DATE: MARCH 14, 2013

FROM: DAVID BAKER, CHAIRMAN, BEAUREGARD REZONING ADVISORY GROUP

SUBJECT: IMPLEMENTATION OF THE BEAUREGARD SMALL AREA PLAN

ATTACHMENT 8

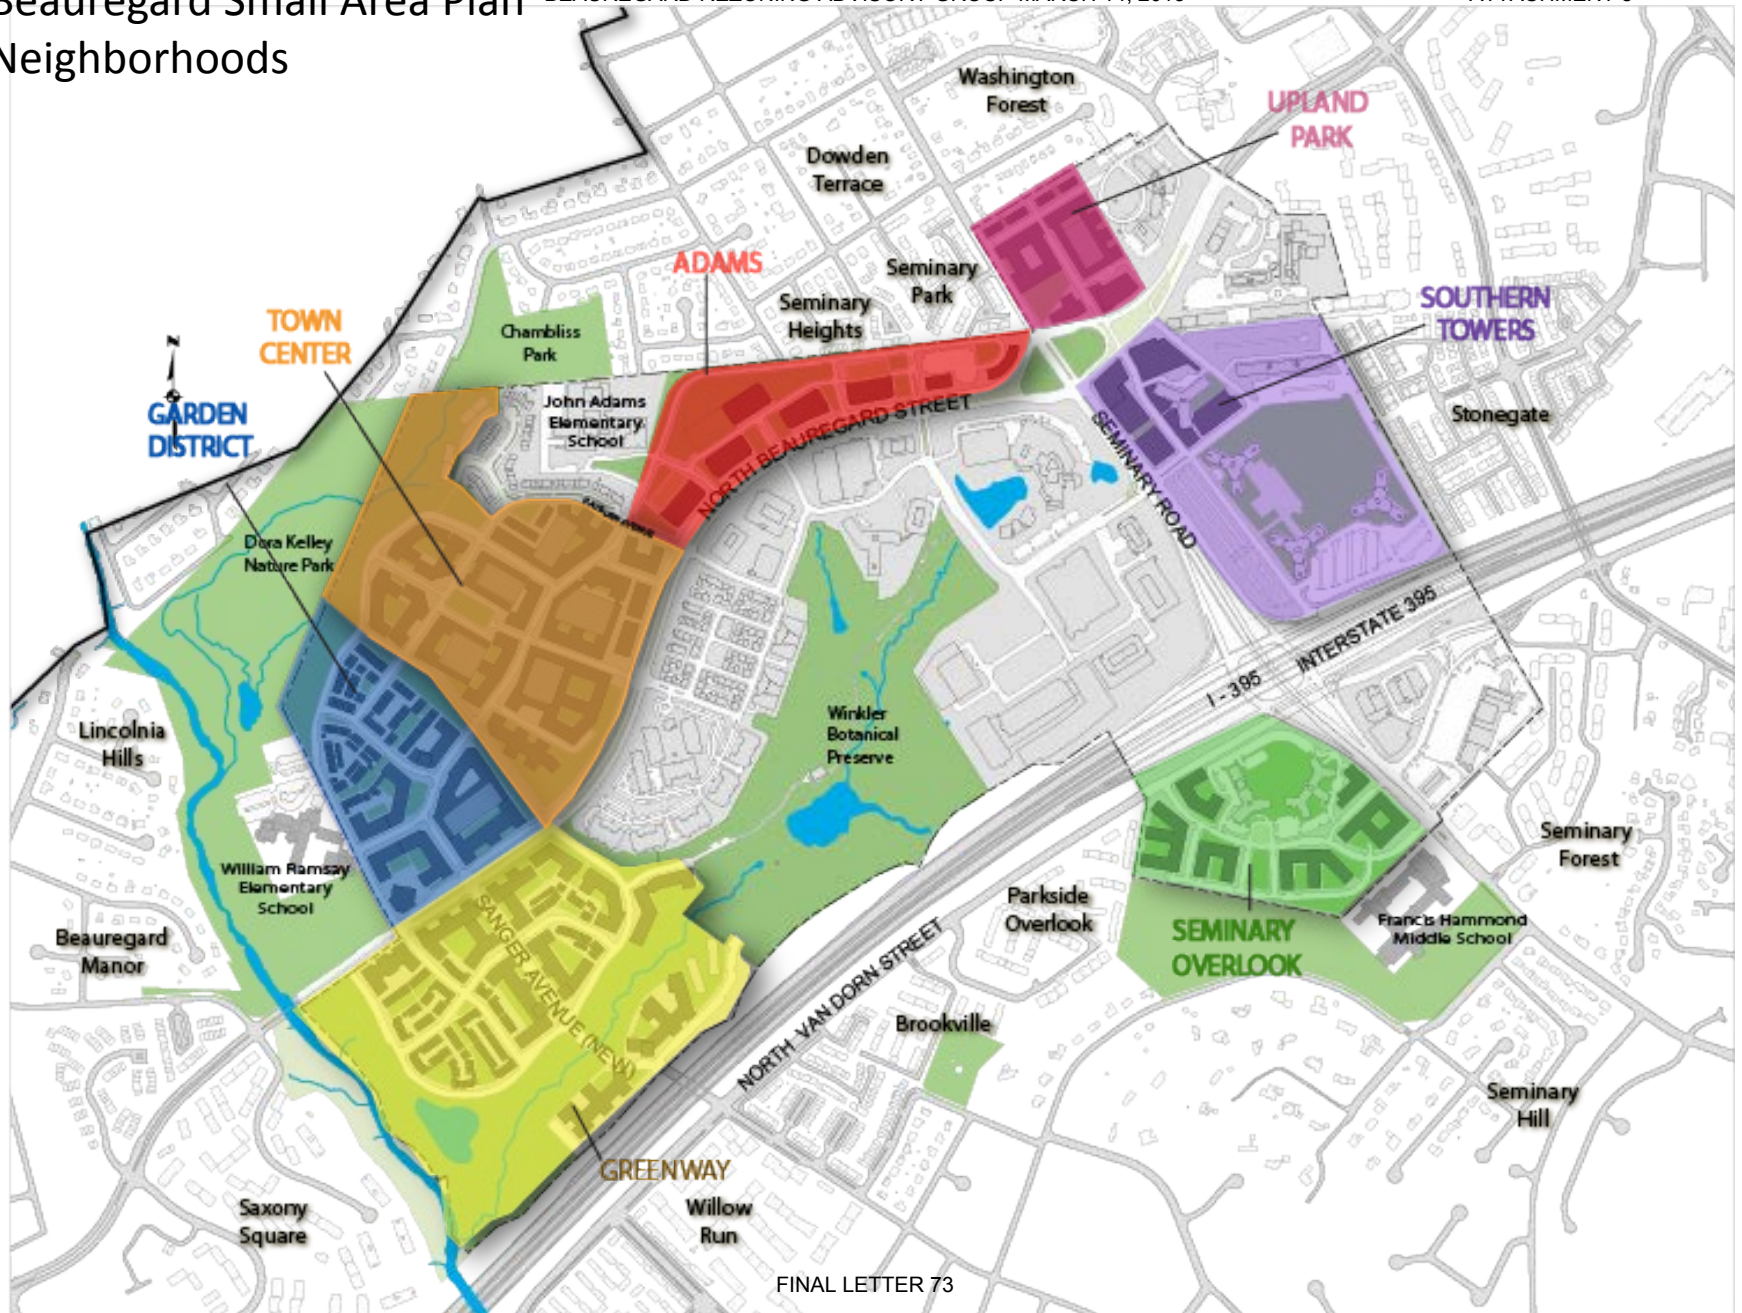
1. A new CDD condition should be added within the Adams Neighborhood (See Attachments 8 & 9) conditions, which should state:
 - “As part of the development special use permit process, any Applicant(s) within the Adams Neighborhood shall consider the following in order to lessen the impacts on the existing adjoining residential neighborhoods. The following shall be evaluated as part of the development special use permit process in consultation with the adjoining residential neighborhoods:
- a) The location of the parallel road shall be examined in order to minimize impacts on the adjoining residential neighborhoods.
- b) Examine reassigning traffic from the parallel road to lessen impacts on the adjoining residential neighborhoods. The examination shall include, but not be limited to, consideration of shifting traffic to the internal street.

- c) Any road adjacent to the adjoining residential neighborhoods shall be designed to minimize vehicular speed and volume and the surface of the road shall include a material to reduce noise.

- d) The type of buffer along the Adams neighborhood shall include, but not be limited to the following: fencing, landscaping, and appropriate lighting given the adjoining residential uses.

- e) Routine access loading will be located to lessen impacts on the adjoining residential uses.
 - f) The surface parking shall generally provide a minimum of a 45 ft. buffer adjacent to the existing townhouses, while accommodating required entrances and circulation.”

2. References and maps within the Beauregard Urban Design Standards and Guidelines showing the location of the streets in the proposed Adams Neighborhood should be revised to include a notation that “The specific design and location of the street alignment will be determined as part of the Development Special Use Permit process.”
